**ASSESSMENT OF THE  
FISH PASSAGE FACILITIES  
AT  
LAKE LODI IN THE MOKELUMNE RIVER**

**September 1992**

**David A. Vogel  
Senior Biologist  
Vogel Environmental Services  
21600 Wilcox Road  
Red Bluff, California 96080**

Figure 6. Fish entrance and flow exit for the Woodbridge Dam fishways, June 2, 1992.

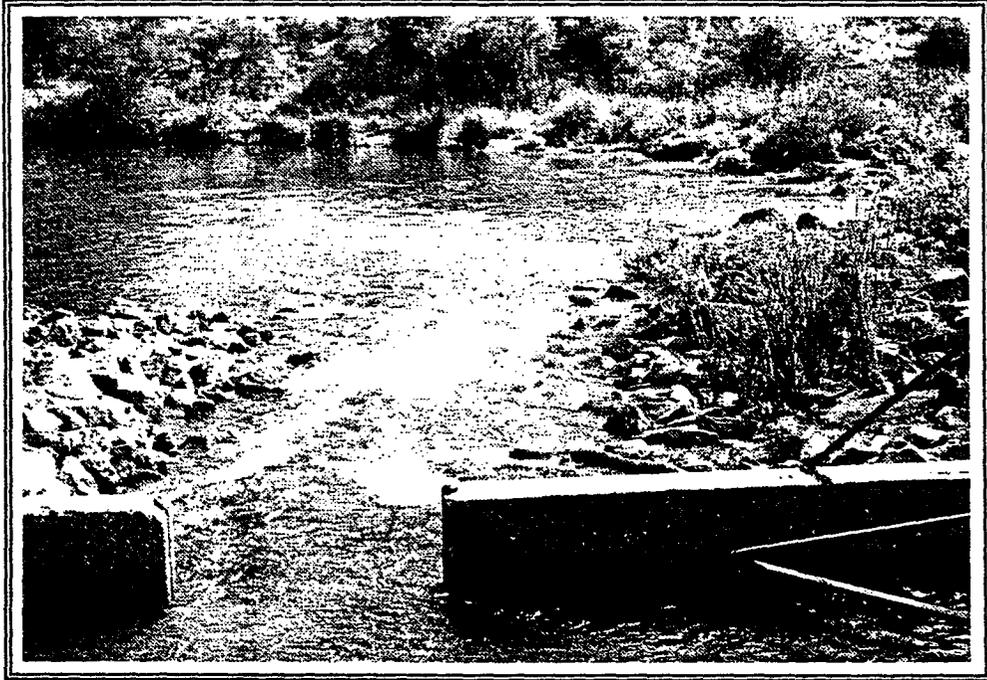
As described in CDFG (1991), the shallow entrance configuration to the fishways at Woodbridge Dam results in suboptimal conditions for attraction because fish attempting to enter the ladders have to swim over a shallow gravel bar under low flow conditions (Figure 6). Vogel et al. (1988) believed that surface entrances to fishways at RBDD may inhibit attraction of salmonids into the fishways. The entrance to the fishways at Woodbridge Dam is much

shallower than those at RBDD. Rainey (1991) recommended avoidance of shallow, high-velocity conditions near a fishway entrance. He suggests that a minimum of a 5-ft pool depth outside the entrance is essential because it provides excellent holding water, aids in reducing spill turbulence, and reduces fish passage delay.

Because the existing tailwater conditions of Woodbridge Dam during low flows result in low water surface elevations relative to the entrance to the fishway, the tailwater elevation could be raised to improve fishway entrance conditions. This measure could be accomplished by adding a hydraulic control downstream of the fishway in the river channel (e.g., large boulders). This hydraulic control would serve to raise the tailwater surface elevation higher than existing conditions and allow better fish access into the fishway because of the resultant deeper entrance conditions and the reduction or elimination of the requirement for fish to swim across the shallow riffle into the fishway entrance. This type of stream channel modification was implemented several years ago downstream of Clough Dam on Mill Creek<sup>3</sup>; the modification improved entrance conditions for salmon and steelhead into the dam's fishway. Careful

An additional option for improving fishway entrance conditions may be the addition of a pool to the existing fishway to eliminate the shallow riffle over which fish have to traverse during low flows. The additional pool would allow for better entrance conditions through the creation of deeper water in closer proximity to the large riverine pool immediately downstream of Woodbridge Dam. As described for the benefits derived from raising the tailwater elevation, an additional pool would provide deeper water at the entrance and reduce or eliminate the need for fish to cross the shallow riffle at the fishway entrance. A hydraulic analysis prior to installation would be necessary to ensure the addition of a pool would not create worse fish passage conditions during high river flows.

Figure 9. The Denil fishway (dewatered) at Woodbridge Dam, June 2, 1992. The bottom of the fishway is in the foreground.

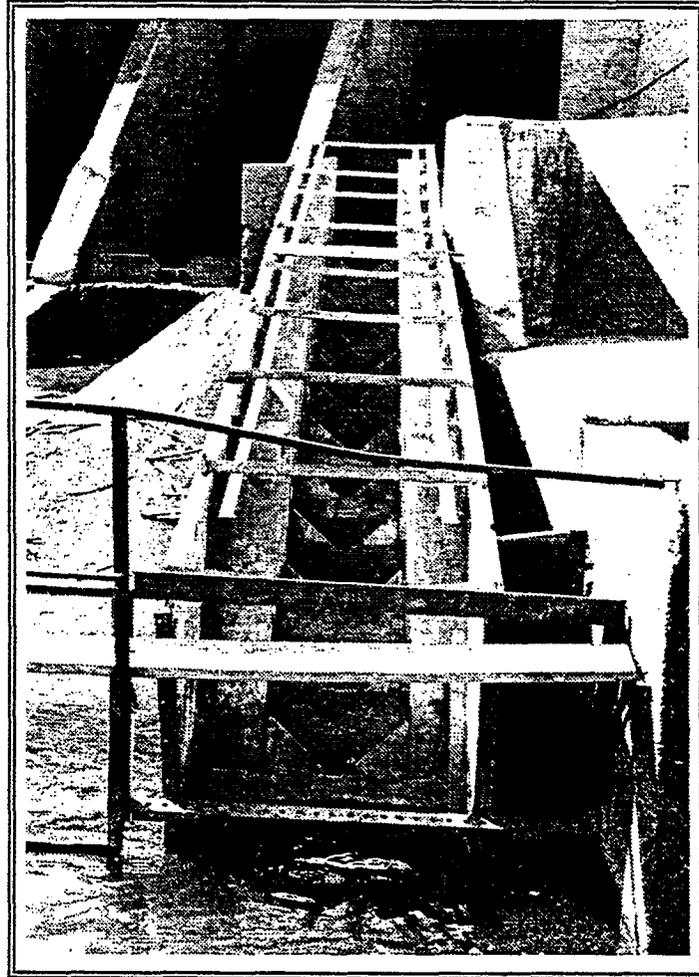
The shallow entrance depth of the Woodbridge Dam Denil fishway could reduce its effectiveness for fish passage. Statick (1969), as cited by Powers et al. (1985), recommended that Denil-type fishway entrances should be submerged to a depth of 2.5 feet. The entrance to the Denil fishway does not appear to be designed or operated at recommended criteria for this type of fishway (Figure 9).

The existing Denil fishway on Woodbridge Dam was reported by CDFG (1991) as having a slope of 11 percent. However, measurements taken from design drawings for the fishway indicated the slope was approximately 23 percent. A figure of the fishway included in CDFG (1991) showed the Denil fishway at a 21 percent slope (Figure 5). It was therefore assumed that the 11 percent value was a typographical error in the CDFG (1991) report. Assuming the existing Denil fishway is placed at either a 21 or 23 percent slope, it is steeper than that reported in the literature for other fish passage facilities and could impair fishway effectiveness. The maximum suggested length for this type of fishway at a 20 percent slope is 30 feet (Powers et al., 1985). The Woodbridge Dam Denil is slightly steeper and longer than these values. In reporting on several Denil fishways used at Cowan, Saskatchewan and Fairford, Manitoba, Canada, Katopodis (1990) stated that the longest Denil fishway section negotiated by fish was 9.5 m at a 12.6 percent slope. Recent fishways installed at Freeport, Ontario had the following design characteristics: east bank fishway, 7.5 m long at 20 percent slope; west bank fishway, three segments each at 10 percent slope with resting pools between segments (Katopodis, 1990). Larinier (1990) reported that more than 100 Denil fishways have been recently installed in France (over a 12-year period), primarily for sea trout and salmon and are generally operated at slopes of between 15 percent to 20 percent.

The existing Denil fishway on Woodbridge Dam does not appear to provide any additional benefits to fish passage and may actually create worse conditions for fish passage and therefore should be removed. The length, slope, and placement of the Denil fishway are sub-optimal. Fish attempting to use this fishway are subjected to a high degree of turbulence at the entrance and are likely disoriented. Substantial energy expenditure would be required for fish

Figure 10. Denil fishway at Woodbridge Dam, January 25, 1991. Note debris at flow entrance.

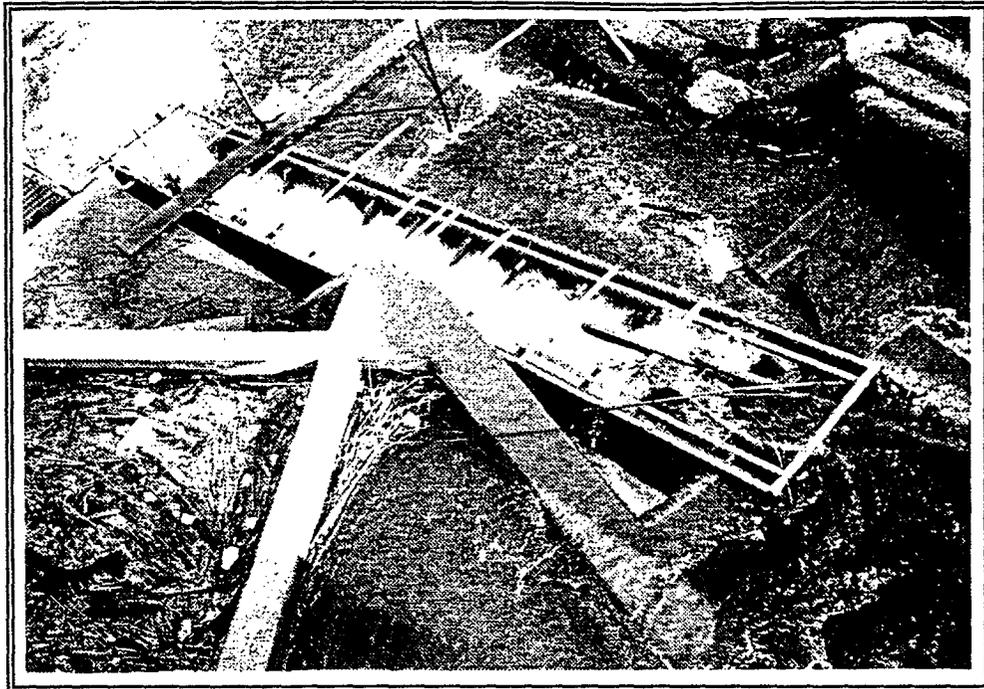
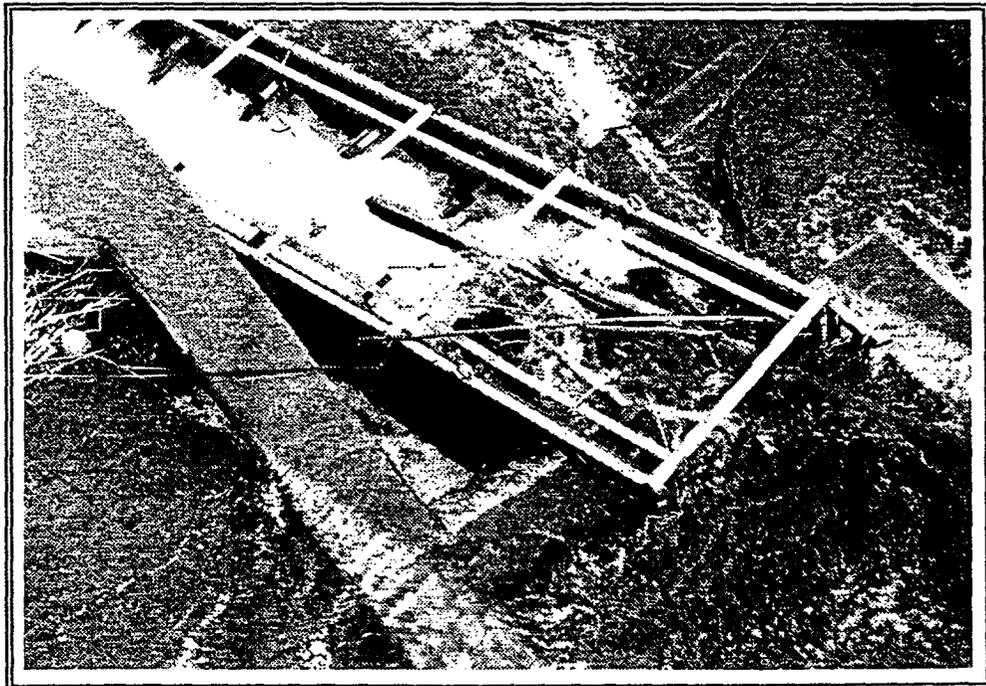
Adequate O&M of fishways is an important consideration of fishways (Rainey, 1991). The accumulation of riverine debris can clog fishways and significantly reduce their efficiency in fish passage performance. On two of three site visits to Woodbridge Dam, riverine debris was wedged in a fishway. Vogel et al. (1988) recommended a more aggressive O&M program for fishways at RBDD as a means of improving fishway efficiency. Based on observations during the site visits and the flow entrance configuration of the Denil fishway on Woodbridge Dam, it is probable that an inadequate O&M program may contribute to reduced fish passage at the dam. During a site visit on January 25, 1991, the top of the Denil fishway (flow entrance) was jammed with riverine debris making the fishway impassible for fish (Figures 10 and 11). During a site visit on March 25, 1992, a large board was found partially blocking the entrance to the base of both fishways in the entrance pool.

All fishways require some degree of routine O&M to ensure the fishways are operating properly. Lack of routine O&M can result in reduced performance of the fishways when riverine debris becomes wedged within the fishway or hydraulic conditions are altered and impede fish passage. The Woodbridge Dam fishways should be inspected on a daily basis during the major migratory periods for salmon and steelhead migration to ensure good fish passage conditions.

Figure 15. Side views of the Woodbridge Irrigation District fish screen bays showing locations of gaps between drum screen frame and support piers.

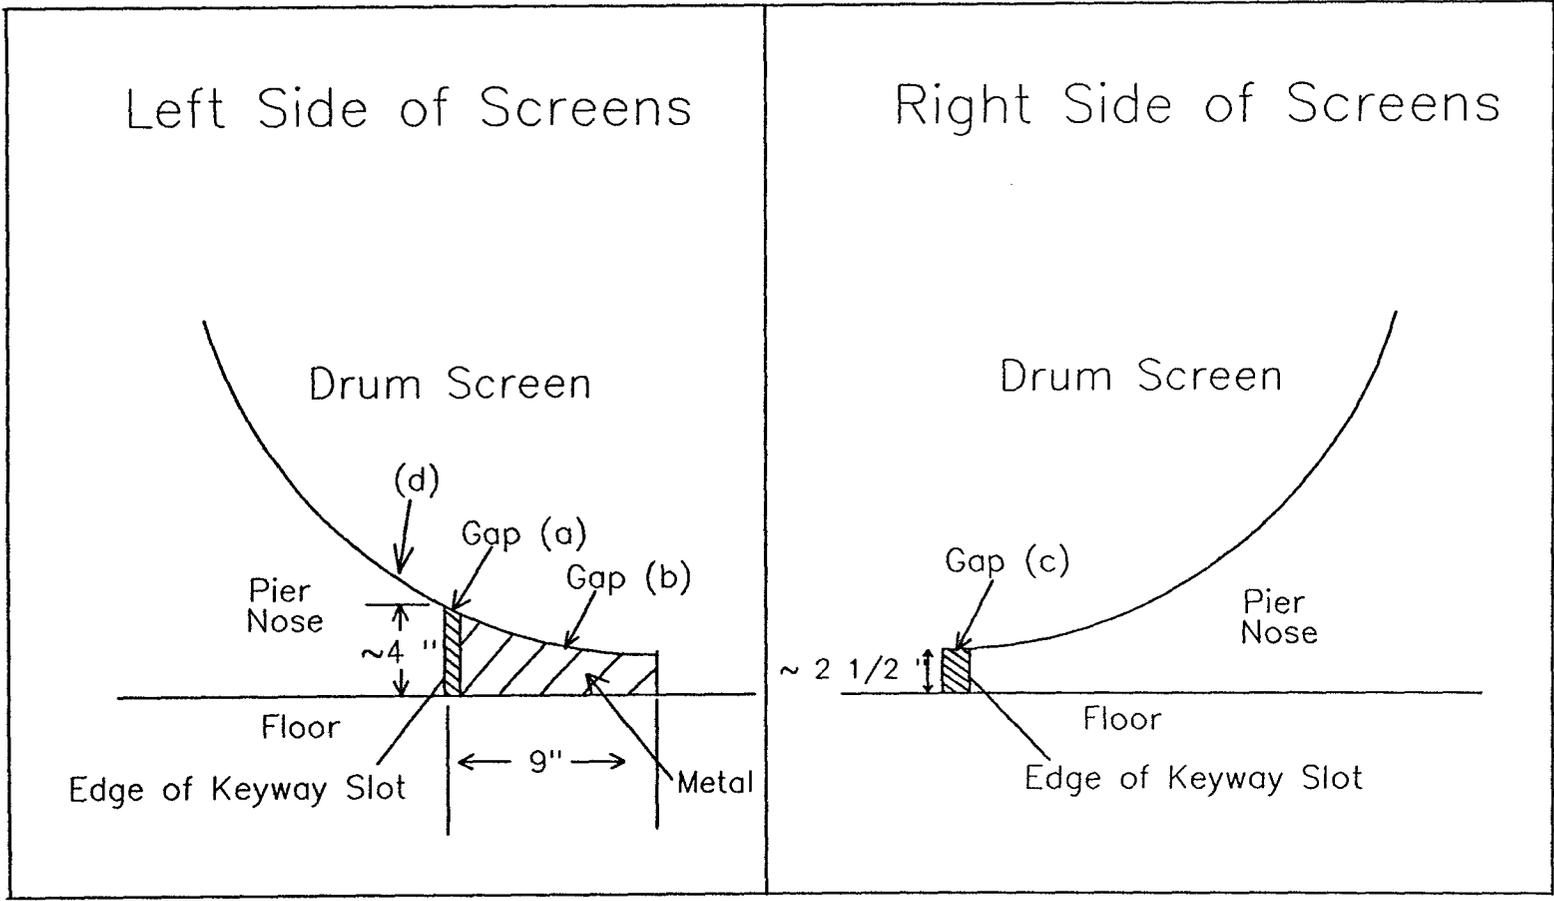
Numerous large gaps were located under the screens which could entrain fish when water is being diverted into WID canal. Figure 15 shows the general location where the gaps occurred at the base of the fish screens and Table 1 gives the specific locations and dimensions of the gaps located. In all but one case, the gaps were located in the concrete keyway slots for the fish screens. These keyway slots are where the entire drum screen and frame are lifted and lowered between the concrete support piers. Fish accessing these slots can easily enter the canal behind the screens by following the slots and entering the canal on the back side (downstream side) of the screen where no seals are present. The gaps are large enough for smolt, juvenile, and fry-sized salmonids to be entrained into the WID canal. There was one instance where one of the rubber side seals was damaged and a gap of approximately 6 inches by 3/8 inch was present. Figure 16 shows the location of the latter gap; in this photograph, note the white pen positioned between the concrete pier and the screen structure. The pen is inserted at the location of the damaged rubber seal. In this photograph, you can also see the metal base of the screen structure positioned in the keyway slot to the right of the pen. This area is comparable to the diagram of the left side of the screens shown in Figure 15. Figure 17 shows the location on the right side of the screens where the keyway slot gaps are present. Note the white pen inserted into the keyway slot. This area is comparable to the diagram of the right side of the screens shown in Figure 15. Following this inspection, CDFG staff repaired the gaps between the screens and concrete piers prior to the filling of Lake Lodi (Anders Christensen, WID Manager, personal communication).

The gaps in the bottom of the screen keyway slots should be eliminated to avoid entrainment of fish into the WID canal. A permanent type of seal (e.g., hard rubber or brush) should be installed on the base of each side of the screen frame in advance of installation for the irrigation season. Alternatively, temporary seals could be installed once the screens are in place but prior to inundation; these seals would have to be replaced each time the screen frame is lifted.

Figure 17. WID fish screen, right side, March 23, 1992. Note pen inserted into the gap at the screen keyway slot.

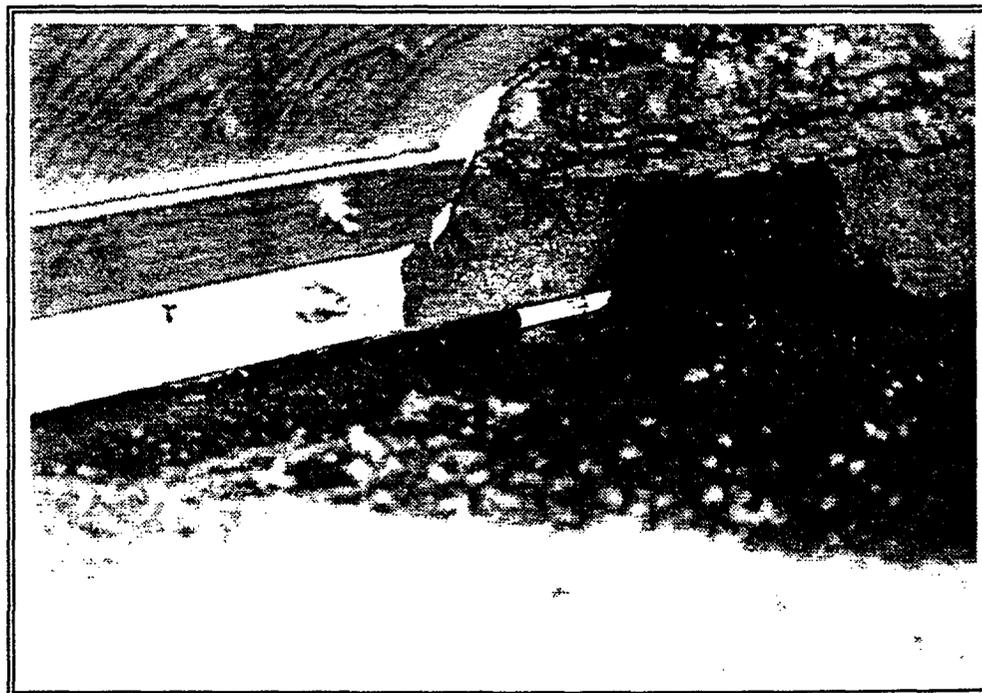
During the inspection, it was noted that silicone caulk had been recently applied at various locations on the screens and screen structure apparently to seal gaps. In some locations, the caulk had been applied continuously to stationary parts of the screen and adjoining parts of the structure which would move when the screen was activated. Under these latter circumstances, it is obvious that some portion of the caulk would sever or become dislodged upon screen activation, possibly compromising the seal integrity.

Figure 18. Conceptual diagram of two Woodbridge Irrigation District fish screens showing location of fish entrapment zones.

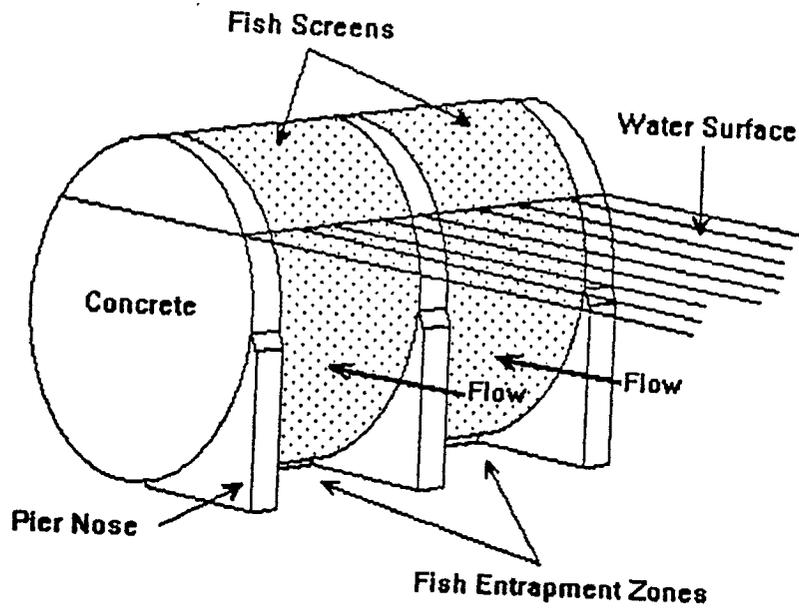
The most notable observation made during the inspection on March 23, 1992 was the presence of large concrete pier noses jutting approximately 5 feet out in front of the base of the fish screens (Figure 18). Those pier noses are shown in Figures 13 and 14. A closeup of the pier nose can be seen in Figure 19. The presence of these pier noses is undesirable because they create hazardous conditions for fish. Modern-day fish screen structures do not possess this feature and are designed with the concrete support piers flush with the contour or curvature of the rotary fish screens. The reason for designing the pier noses flush with the screen is to allow fish to follow a path of least resistance past the screens until they enter a downstream fish bypass. Existing CDFG fish screen design criteria states, "Screen faces shall be placed flush with any adjacent screen bay piers or walls to allow an unimpeded flow of bypass water parallel to the screen face". The presence of the pier noses interrupts tangential flow along the face of the screens toward the fish bypass system. Young downstream migrant salmonids entering a screen bay between the pier noses encounter only flow being entrained in a perpendicular direction through the screens. The fish can escape these areas only by swimming against the flow to escape these "entrapment zones" (Figure 18). This behavior is uncharacteristic of downstream migrant salmonids. Fisher (1976) believed that fish approaching the WID fish screen "sounded" in front of the screens; this behavior would make

them vulnerable to the entrapment zones at the base of the structure. Rainey (1985) pointed out that under these conditions, juvenile fish must either sustain swimming velocity until a bypass entrance is found or they must seek a small opening at inside or bottom seals. Emphasizing the danger to fish, he stated, "The unfortunate reality of a screen perpendicular to flow is that fish must be strong, innovative, and lucky to survive". Similar types of fish entrapment zones were recently found on the CDFG fish screen at the Glenn-Colusa Irrigation District diversion on the Sacramento River (Thompson, 1992).
